# City of Mississauga

### City Department and Agency Comments

Date Finalized: 2025-02-27	File(s): A308.24
To: Committee of Adjustment	
From: Committee of Adjustment Coordinator	Meeting date:3/6/2025 1:00:00 PM

**Property Address:** 3790 Morning Star Dr

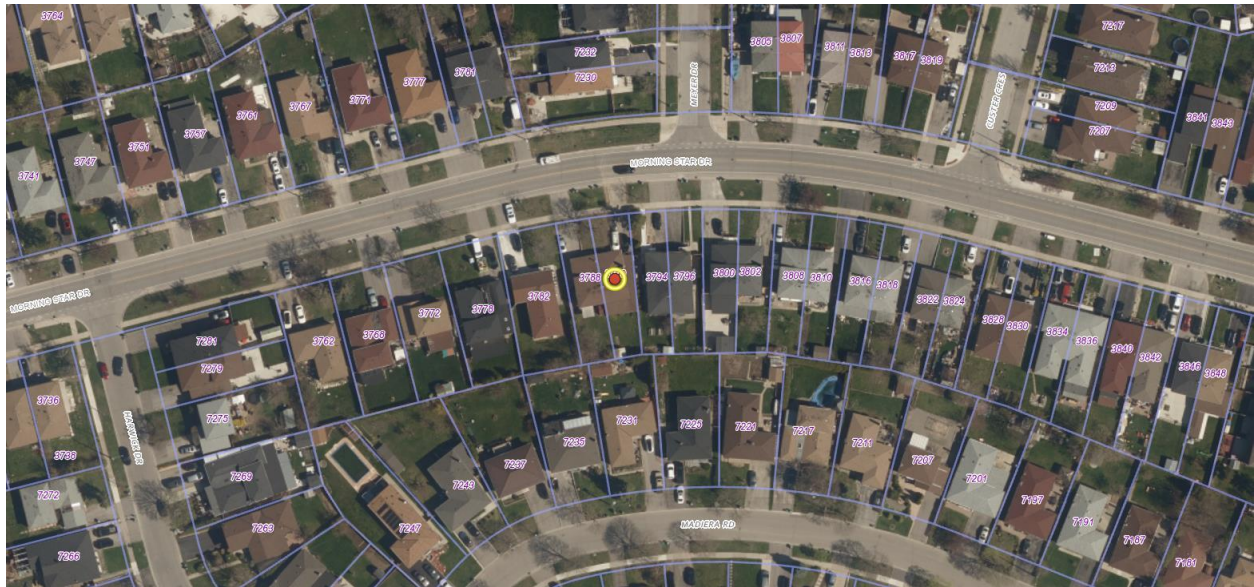
Enclosed for Committee's reference are several photos which depict the subject property, in particular the excessive canopy constructed at the rear and side of the dwelling. We note that the Site Plan submitted under the Building Permit Application, file BP 9ALT23-10208 and Site Plan circulated with this application are similar. Both the Site Plans indicate that there is a 0.62M setback to the property line which we assume would be a measurement to the extent of the "Proposed Canopy".

From our site inspection, and as clearly depicted in our submitted photos, and assuming that the existing fence is in the correct location, the 0.62M setback clearly does not exist. In this regard we question if the applicant will be re-constructing the canopy to reflect a 0.62M setback, or alternatively if this variance application would have to be amended to reflect the reduced side yard setback.

If the constructed canopy is to remain in its current location, this department would not support the request as the existing drainage pattern is not acceptable. The downspouts from the dwelling are directed onto the canopy areas where the additional drainage from the canopy is then directed to two downspouts which are not functional as they exist. As clearly depicted in the photos the downspout is connected to a PVC pipe abutting the driveway, the PVC pipe is broken and clearly not functional. Even if the PVC pipe was not broken, this would not be acceptable. It should also be noted that the abutting property has a reverse grade driveway, and every effort should be made to alleviate any drainage from this property being directed to the abutting property.

Alternatively, should the existing canopy be modified to reflect the depicted setbacks as per the Site Plan circulated with the Building Permit Application, then any requirements can adequately be addressed through BP 9ALT23-10208.
